# CITY OF ALBUQUERQUE

**RE: Lot 15 Block 2 Unser Cliffs SAD 227  
6912 Rimrock NW  
Grading and Drainage Plan  
Engineers Stamp Date 7/18/17 (E10D040)  
Pad Certification Date 12/12/17**

James D. Hughes, P.E.  
Principal Engineer, Hydrology  
Planning Department

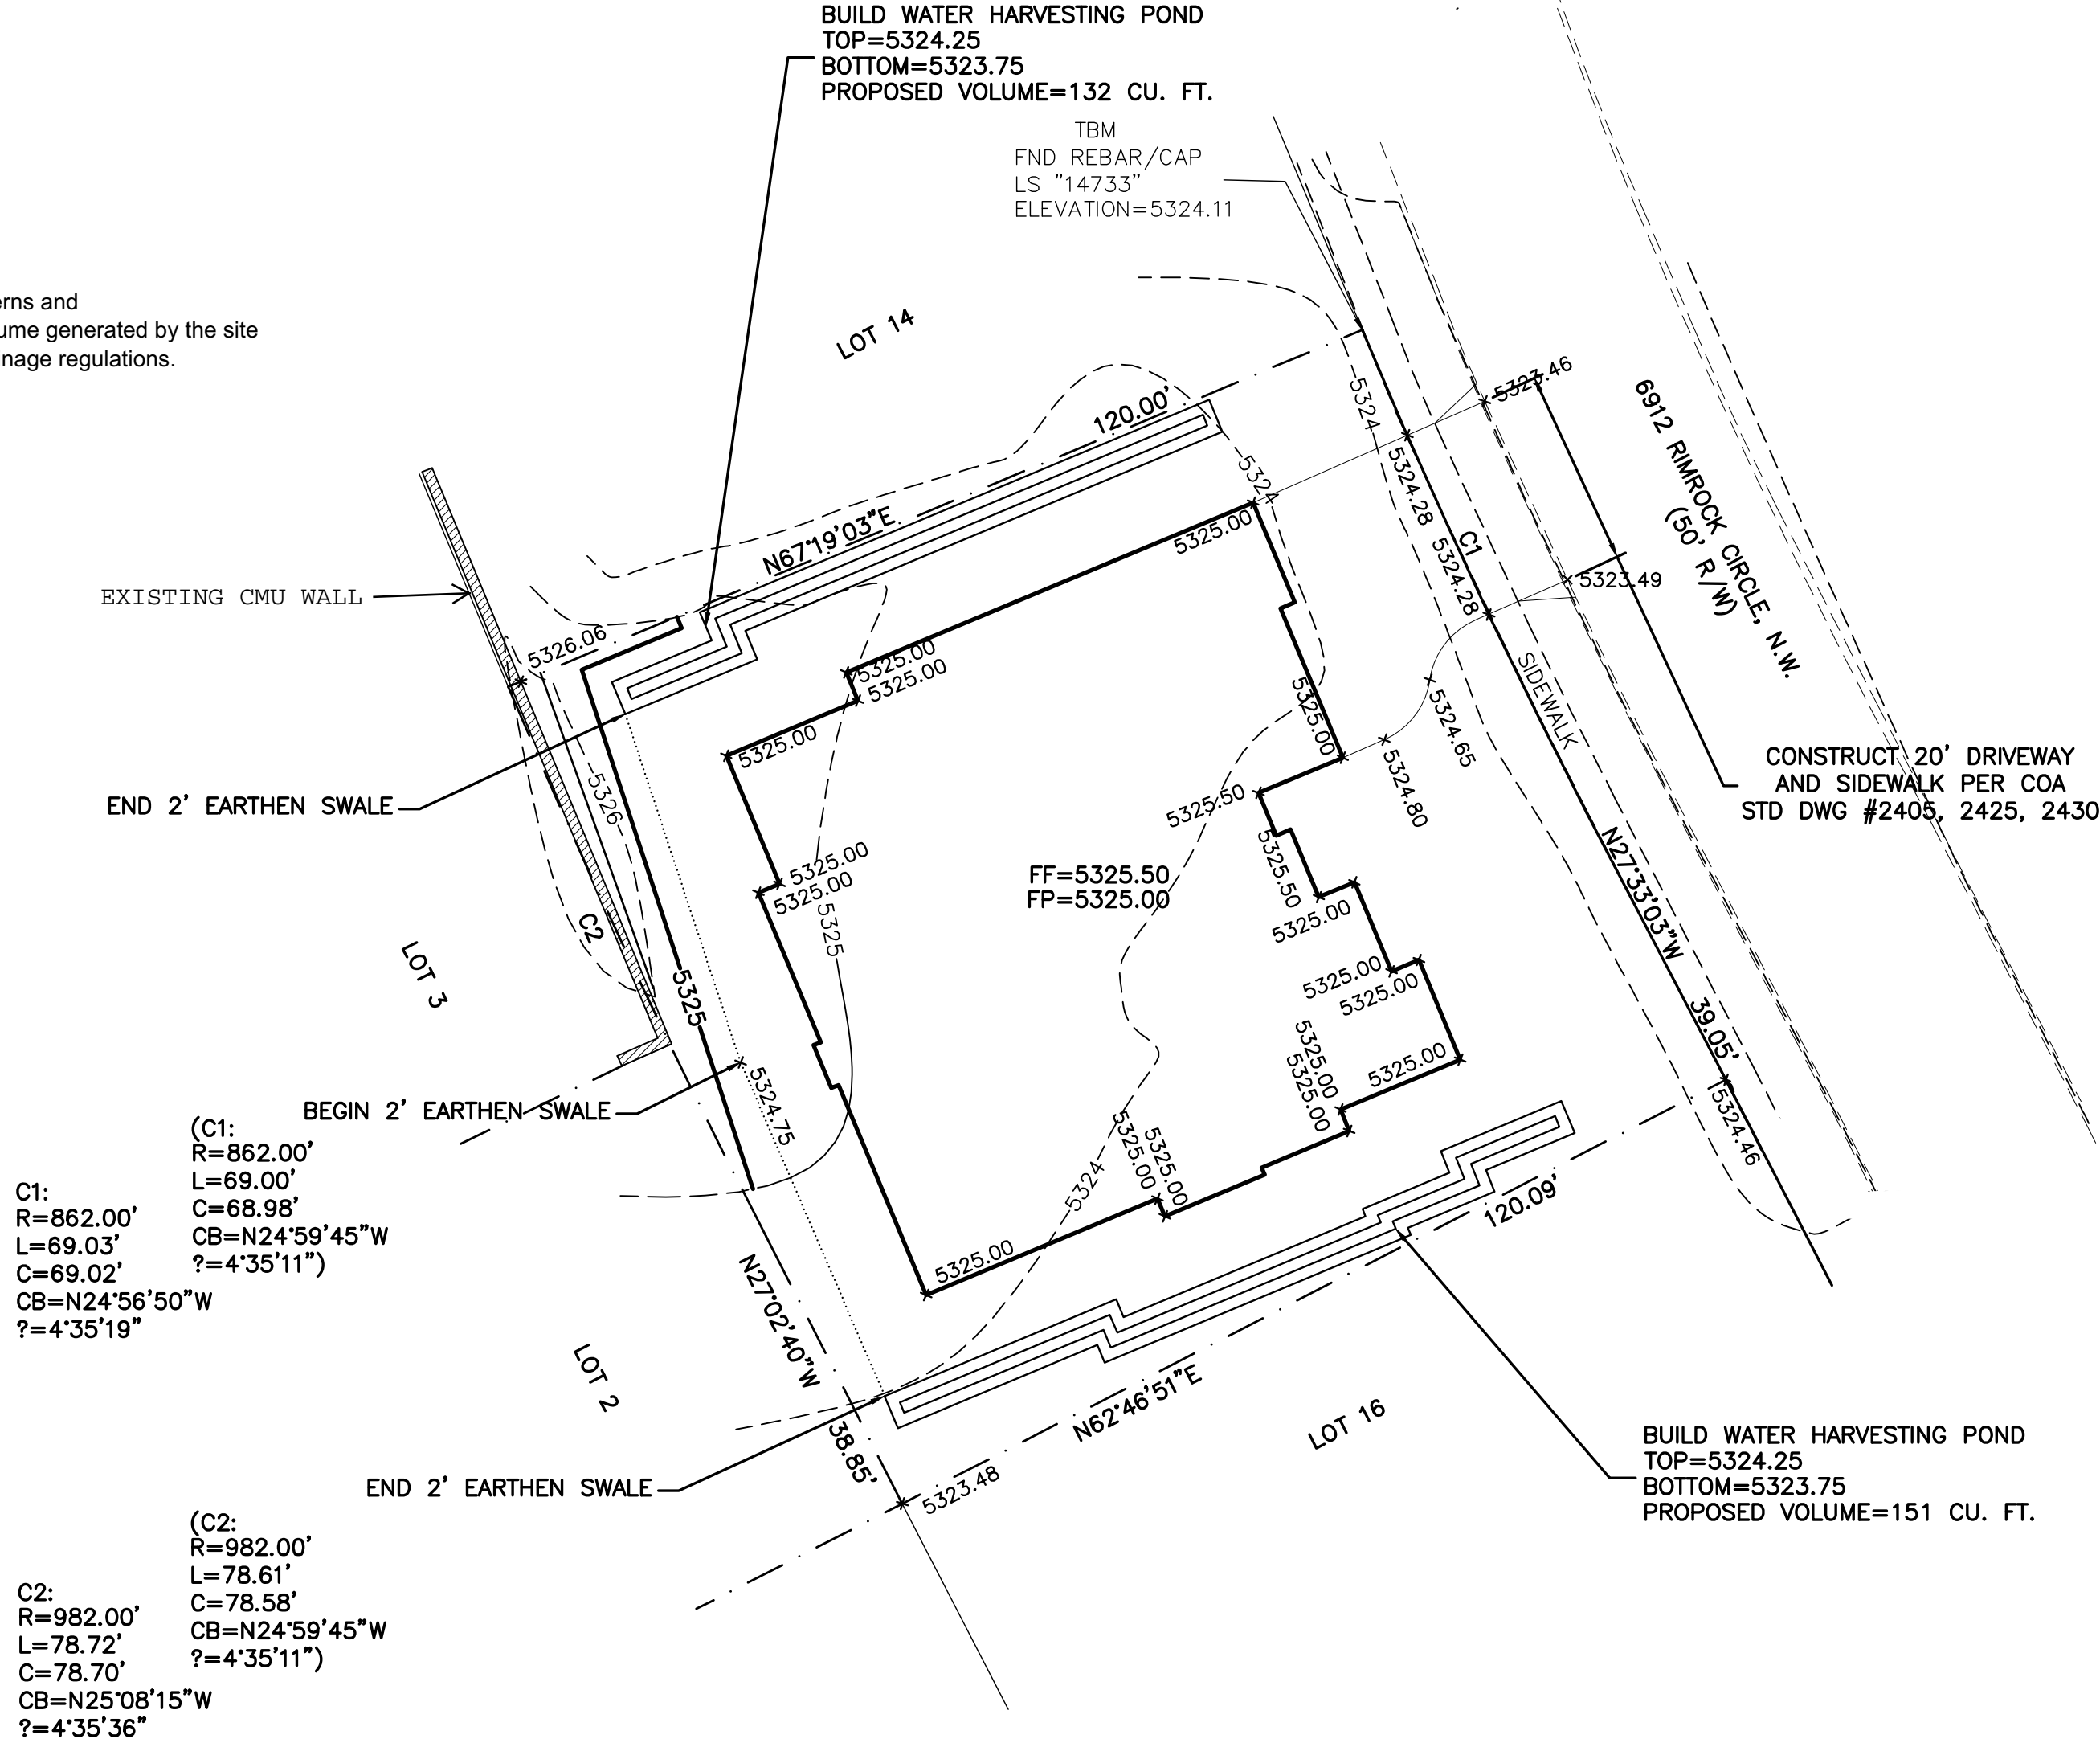
Based upon the information provided in your submittal received 12/12/17, this plan is approved for Building Permit.

Reiterate to the Owner/Contractor that a separate permit for a garden/retaining wall must be obtained, with the approved G&D plan dated 7/18/17.

Prior to Certificate of Occupancy release, Engineer Certification per the DPM checklist of this plan will be required.
